comments/suggestions on Wendy's 4900 Central

DRAW	JEFF W(
SANT	CO 87108	JOB NO.	2016043		
PROJECT TITLE WENDY'S RESTAURANT	4900 CENTRAL AVE SE ALBUQUERQUE, NEW MEXICO 87108	PROJECT MANAGER	JEFF WOOTEN	SHEET TITLE	Grading Plan
DATE:			sheet-		
12.15.16				1	1

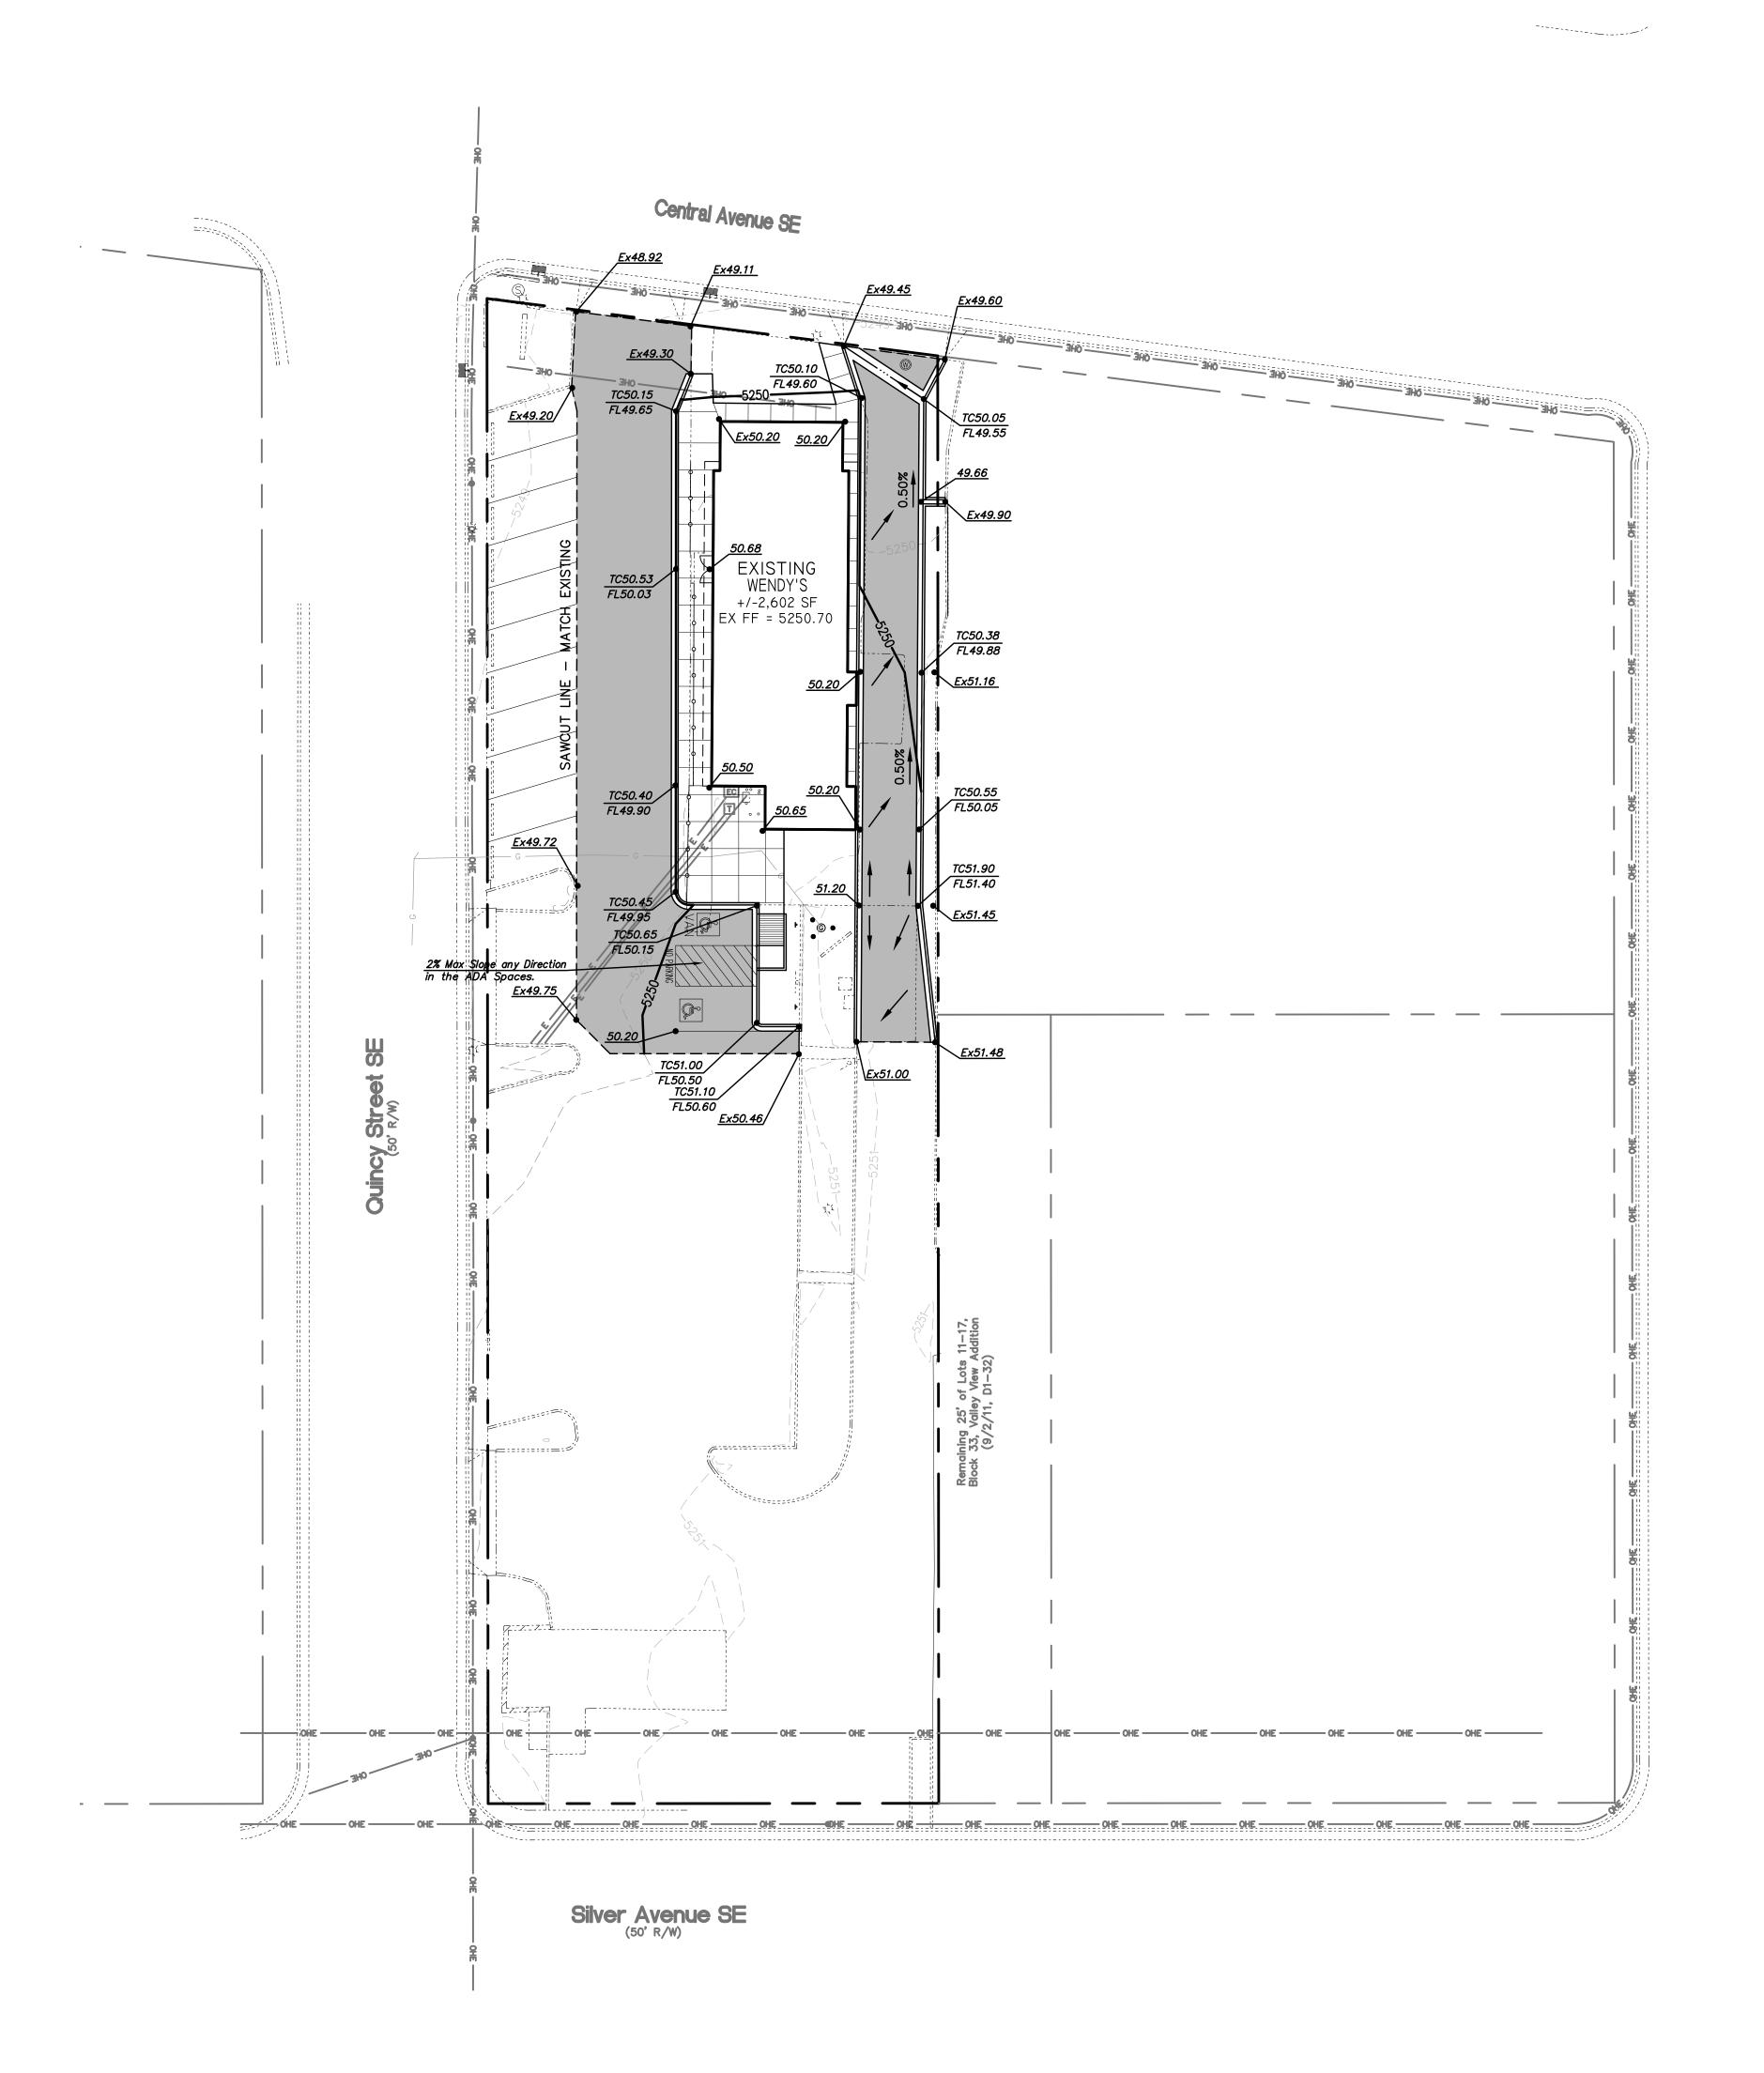
- 1. Include a narrative. All plans require a narrative.
- 2. There are offsite flows that drain through an existing curb cut. Either quantify or say something about how the existing curb cut works and should continue to work in the future.

- 3. Proposed conditions Q and Volume. I don't think you need to provide calcs, but you should mention that proposed flows and volumes will be slightly lower than existing flows and volumes due to the landscaping.

- 4. It appears to be relatively painless to have flows along the eastern edge drain into the proposed landscape area. Provide curb opening at FL 49.88 and flows could leave the landscaping just upstream of the proposed channel. Section of landscape area could look like landscape buffer swale (5:1 side slopes).

- 5. It appears that construction of the new channel is partially on the lot to the east. Provide written (email OK) approval from the property owner or authorized agent (e.g. General Manager).
